L. William Pearce
Vice President724-682-5234
Fax: 724-643-8069July 8, 2005
L-05-112U. S. Nuclear Regulatory Commission
Attention: Document Control Desk
Washington, DC 20555-0001

**Subject: Beaver Valley Power Station, Unit Nos. 1 and 2
BV-1 Docket No. 50-334, License No. DPR-66
BV-2 Docket No. 50-412, License No. NPF-73
Responses to a Request for Additional Information in Support of License
Amendment Request Nos. 302 and 173**

Non-Proprietary responses to RAI dated May 5, 2005

Figure E.7-9
BVPS-2 3-Inch Break
Broken Loop Pump Suction Cross Over Leg Liquid Level

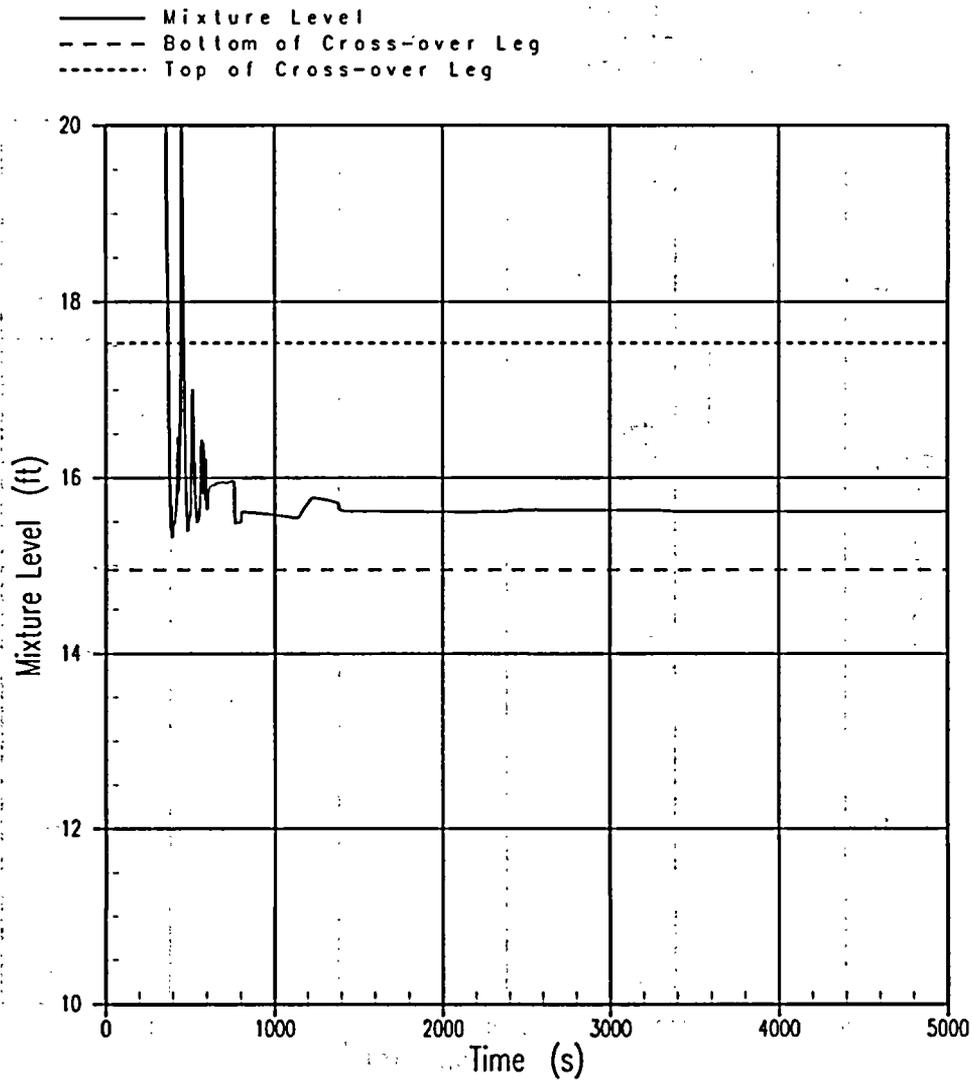
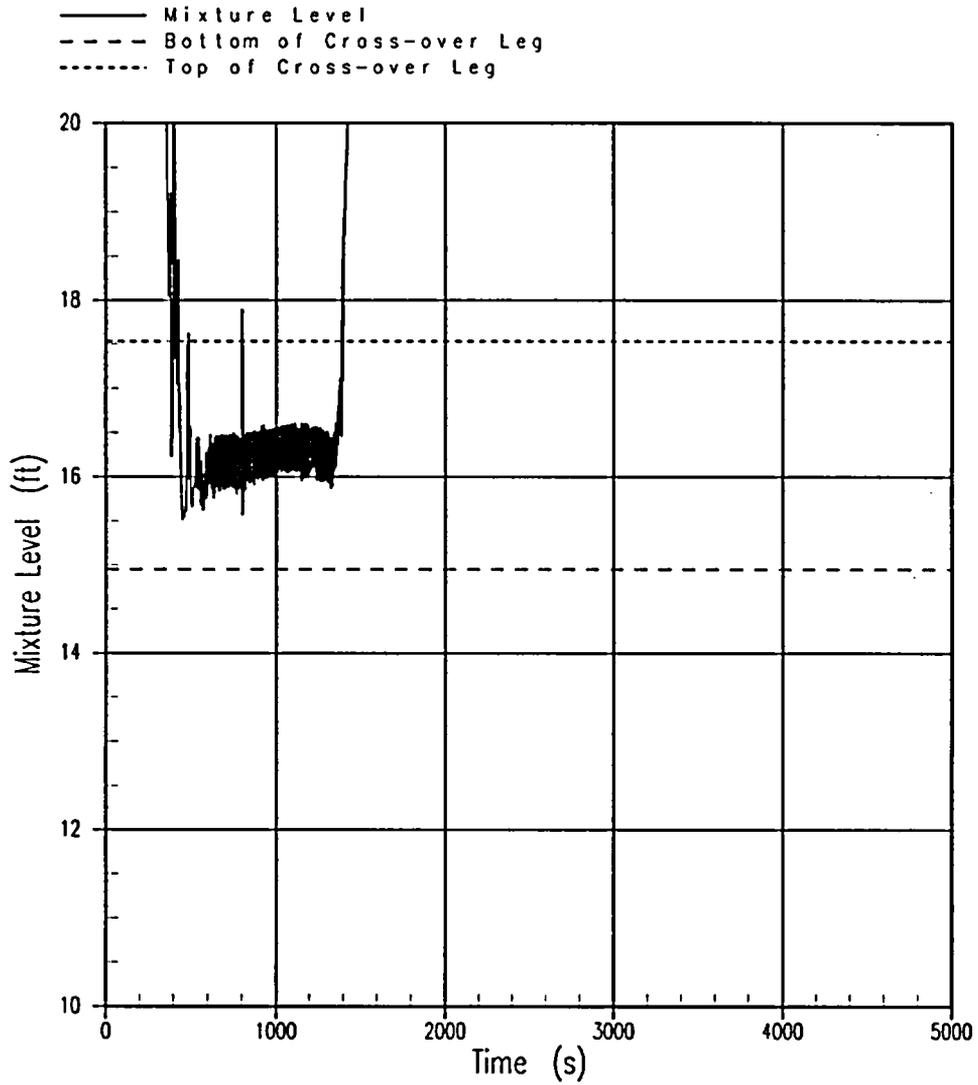
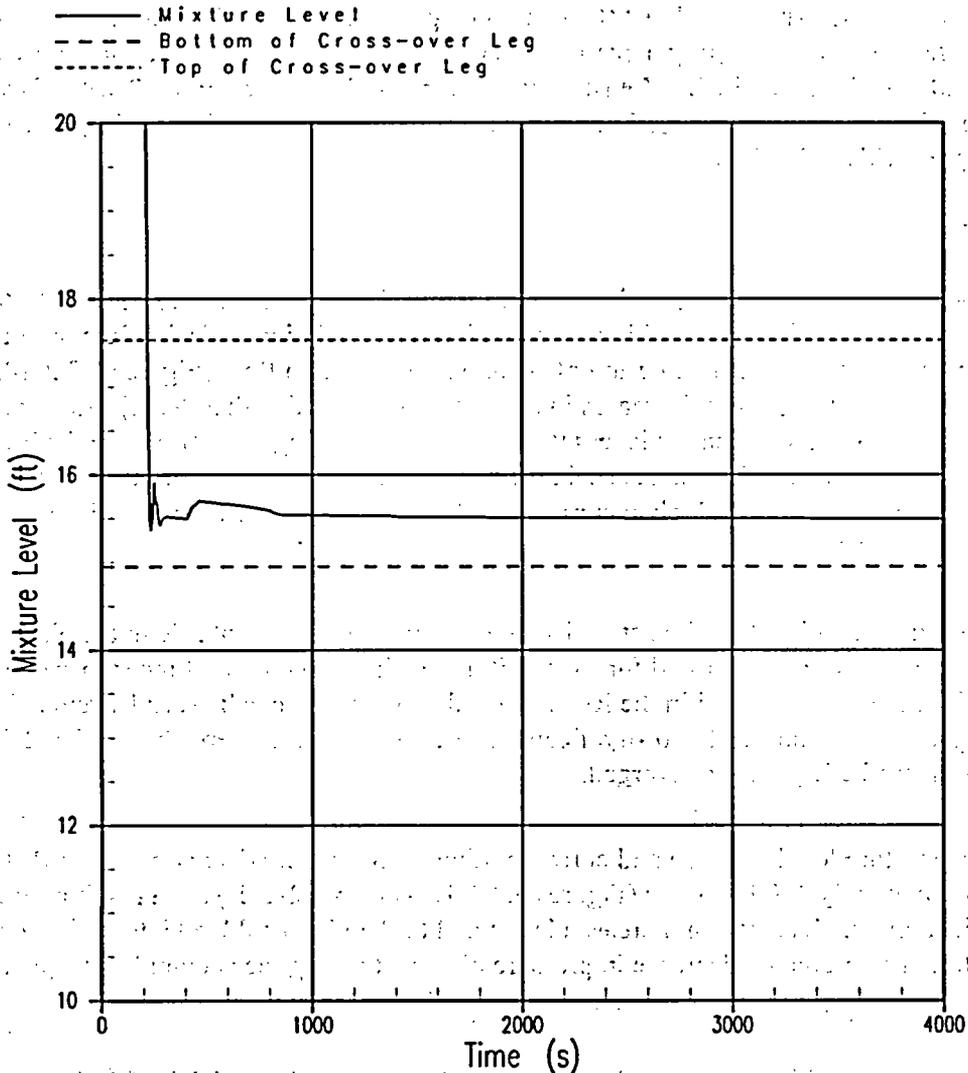
The reactor coolant pump (RCP) suction cross-over leg in the NOTRUMP-EM is modeled as [

]^{ac}
Figures E.7-1 through E.7-11 plots summarize the mixture level associated with the steam generator output plenum to horizontal cross-over leg piping with respect to time for BVPS-1 and 2.
